SUBJECT: DIFFERENCES BETWEEN 101.503 AND 101.503-1:

JAN. 11, 1939

MODELS 4620A, 4621A, 4641A, SEARS, ROEBUCK & CO. 4642A, 6050, 6051, 6150 Chas. 101.503-1

CHASSIS 101.503-1

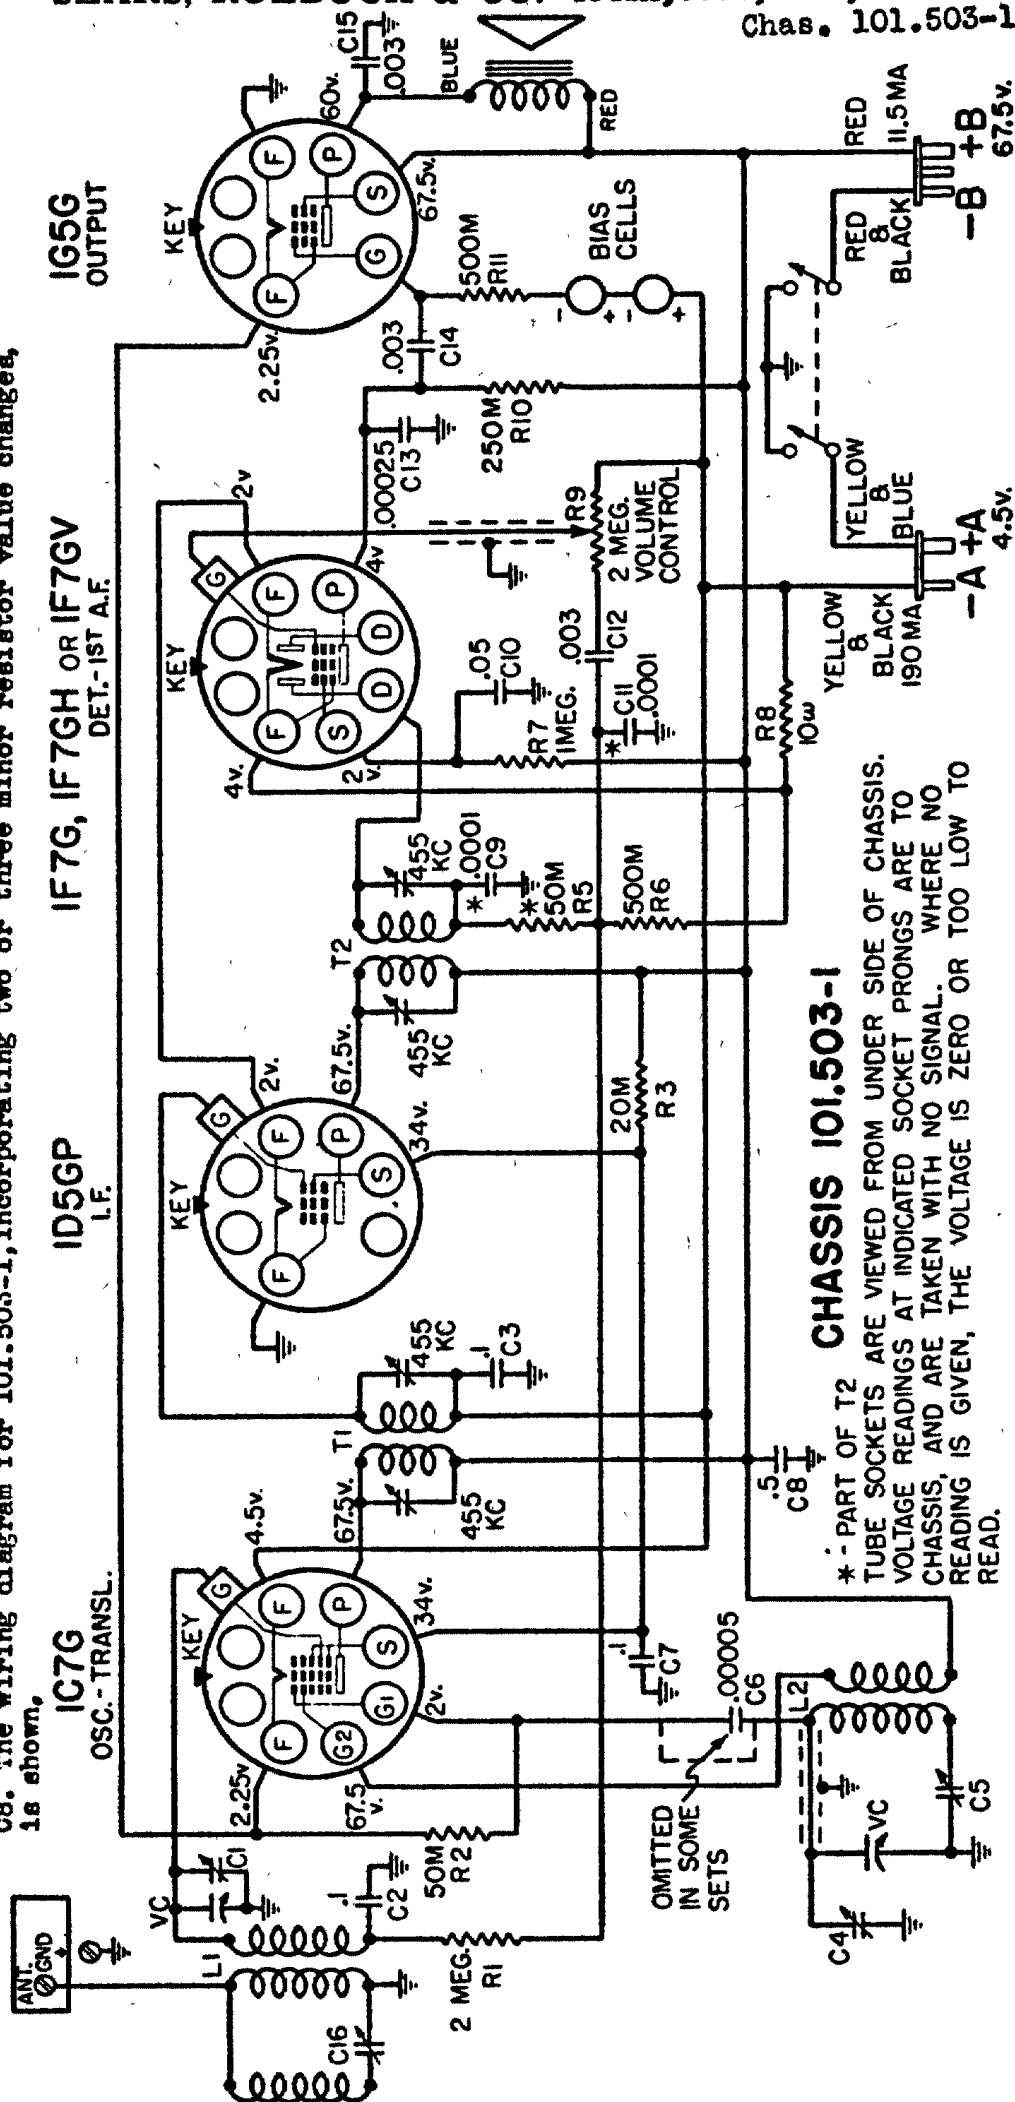
Chassis identified by 101.503-1 use 455 kc IF instead of 465 kc as used in 101.503. Different knobs and a different volume control also are used.

The .5 mfd. condenser, listed as C5 in the original Manual should have been listed as C8. The wiring diagram for 101.503-1, incorporating two or three minor resistor value changes, is shown.
